PERMIT

SEWAGE DISPOSAL SYSTEM

P 58066

REPAIR - PURPOSE - SEPTIC TANK HAS COLLAPSED. (Replacement)

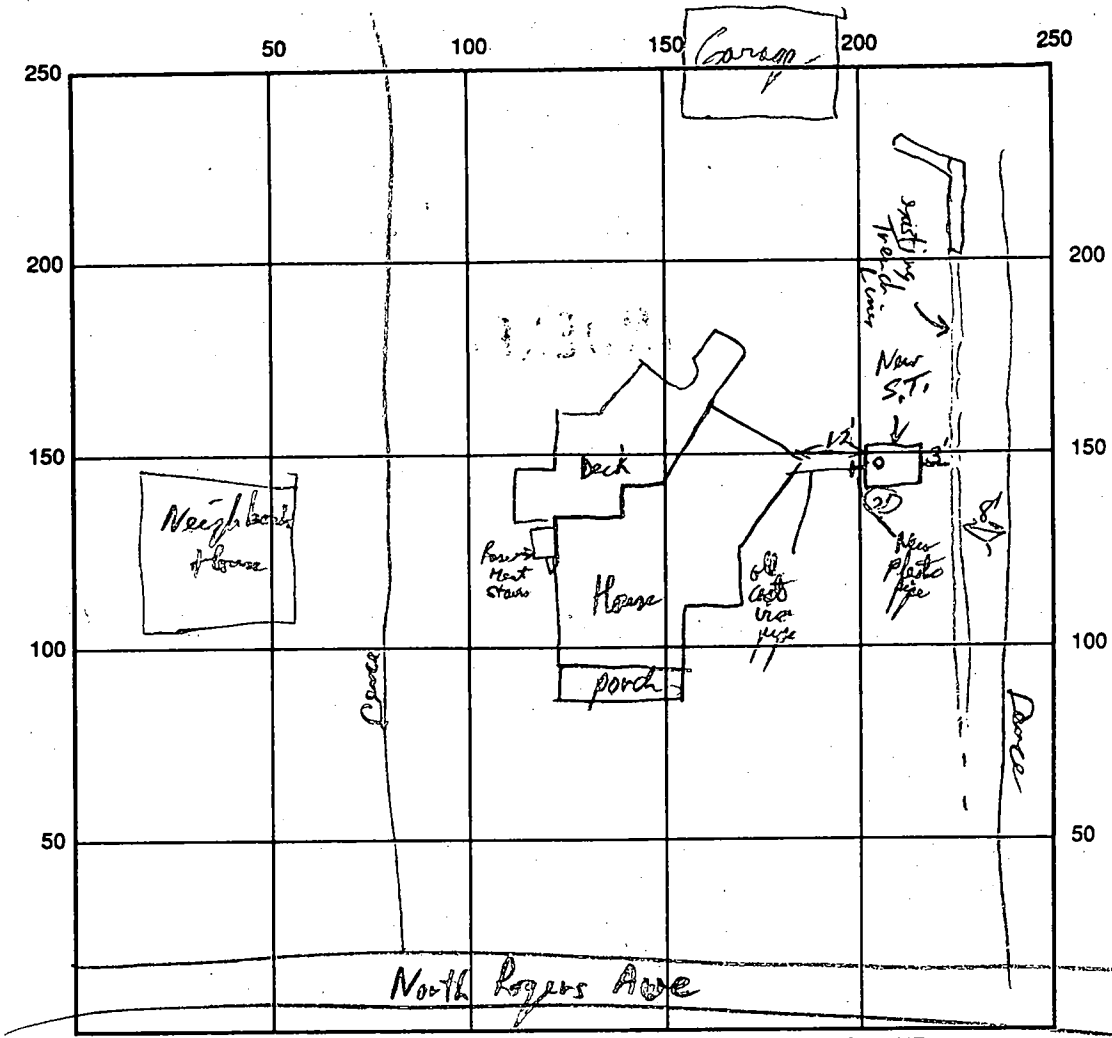
REMARKS: Septic Tank Placement & size OK for 3 person house - Existing Septic Trench appears functional
Tie in to House Connection (cast iron) to New Sched 40 with Fernox Connection - No Dist box
Needed - appears to be another septic trench toward Road (Not shown 1975 permit) ok
to connect to both. OK to cover when finished. P/P 6/5/97
